USM-EXHCV-26/08
FORD CARGO
PRODUCT IMPROVEMENTS
&
SERVICE ACTIONS AND
RECOMMENDATIONS

Updated
31/08/2008

HEATER TAP PROBLEMS

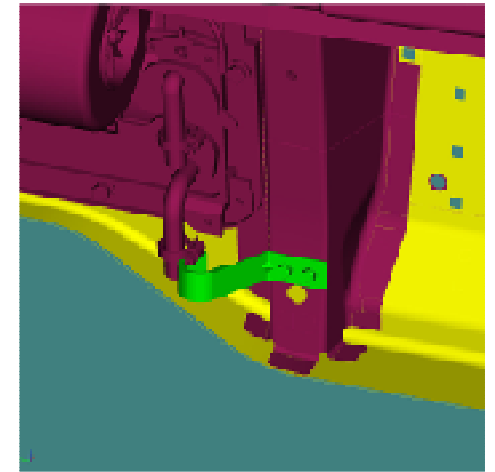
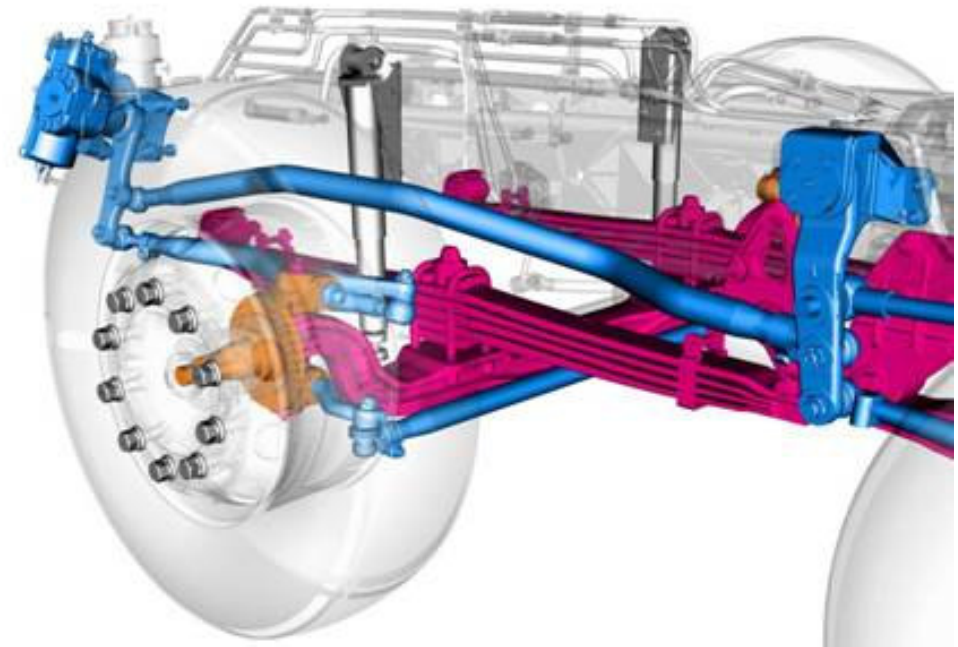
Problem : Heater tap gets broken

Action : Bracket added to hose connection in order to eliminate the vibration

RIGHT / LEFT TRACTION ON 18XX VEHICLES

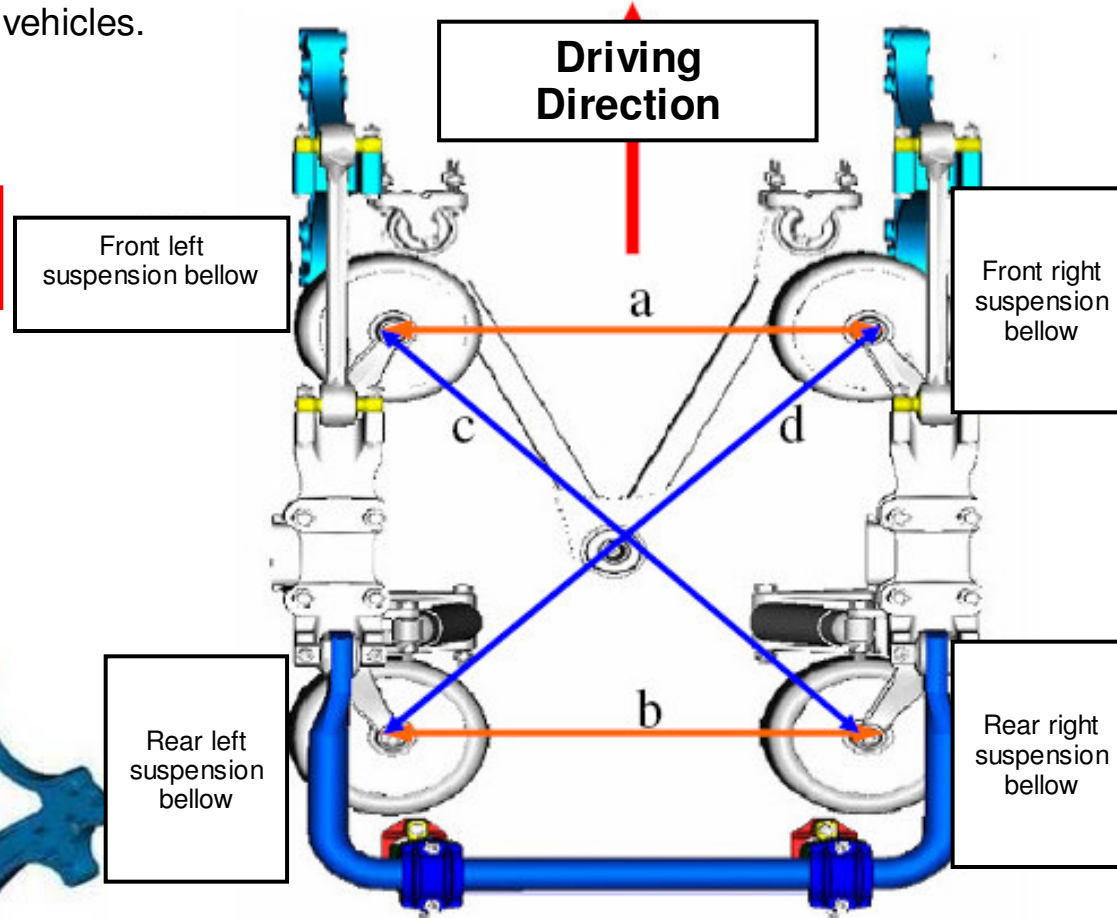
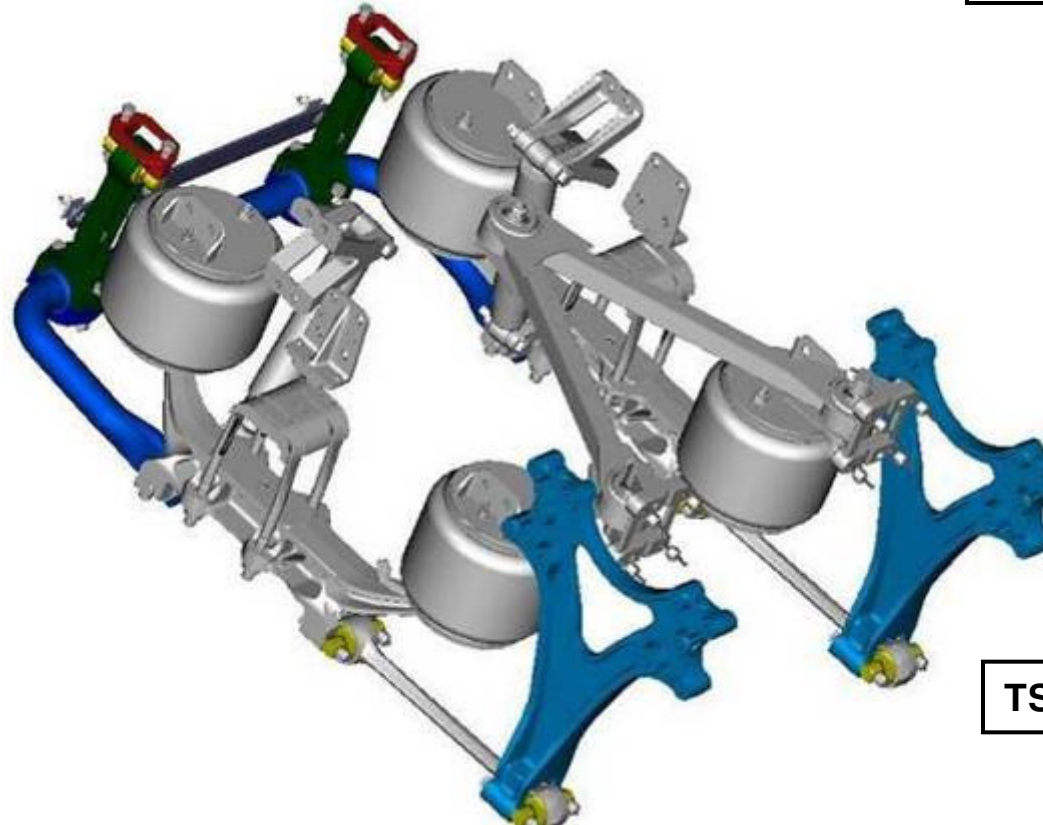
Air suspension bellows should be checked on complaint vehicles.
Improvement started with the vin **68487**

**Values for a and b should be 766-768 mm;
and for c and d should be 1126-1128 mm**

HANDBRAKE SENSOR QUALITY PROBLEMS

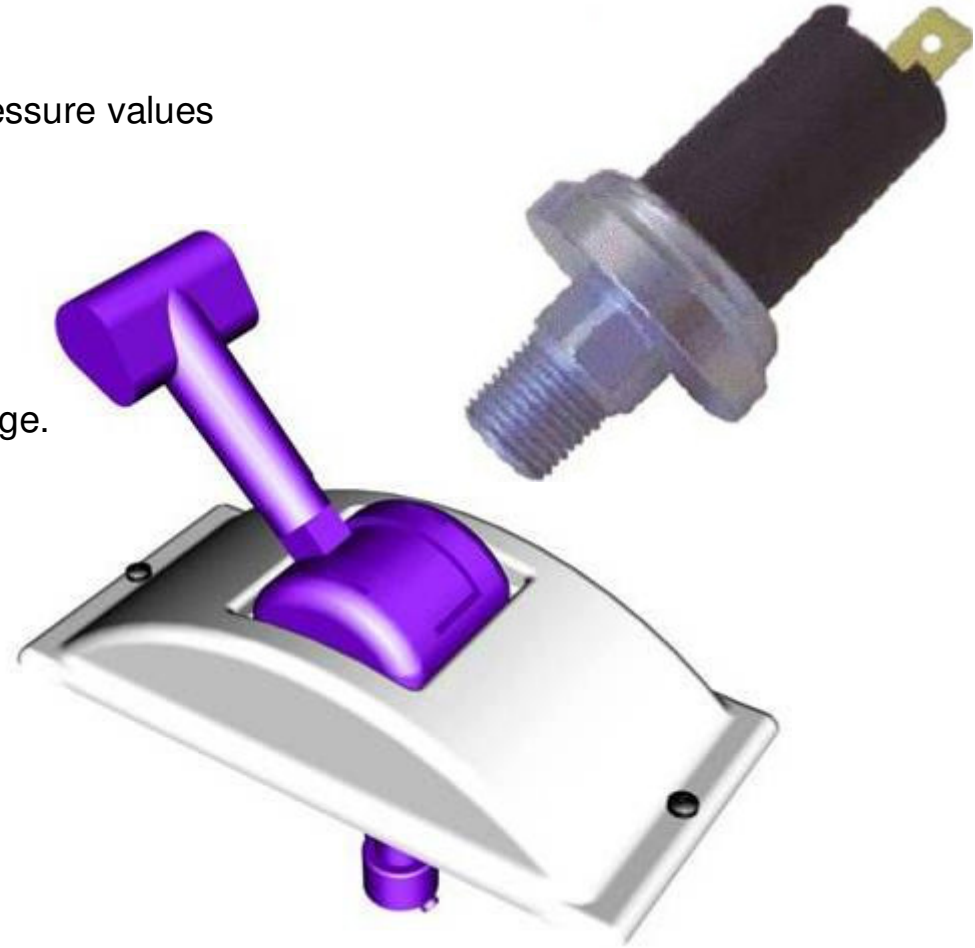
Supplier quality problems. Incorrect adjustment of sensor pressure values

From 20.12.2005 on 100% controlled brake sensors have been into production.

New brake sensor have been released by the supplier change.

New part no. **7C46-2937-AB**

GEARSHIFT MECHANISM JOINT PROBLEMS

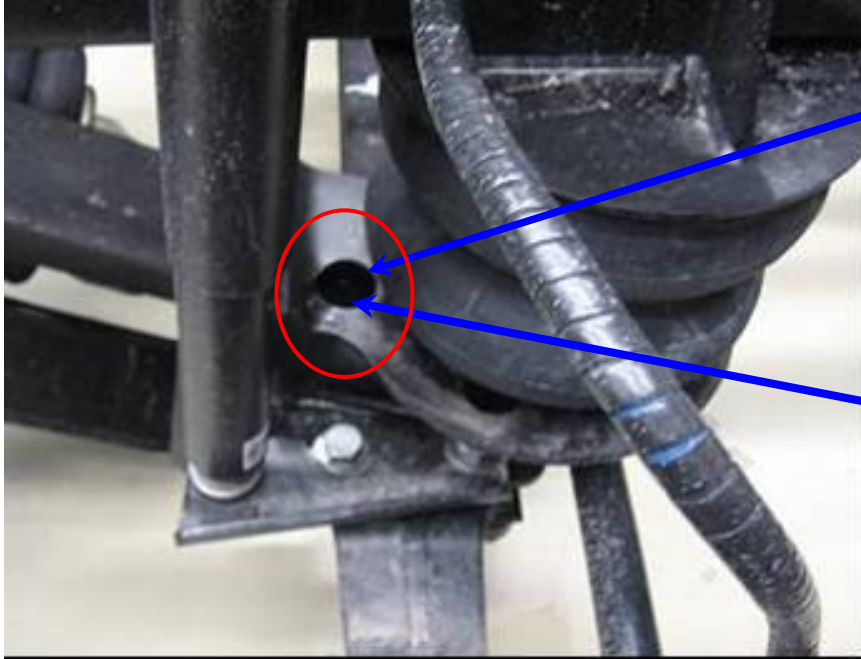
Joint breaks of gearshift mechanism; problem can be fixed by replacing a joint instead of complete assembly .

Part no: **7C46 - 7R361 - AA**
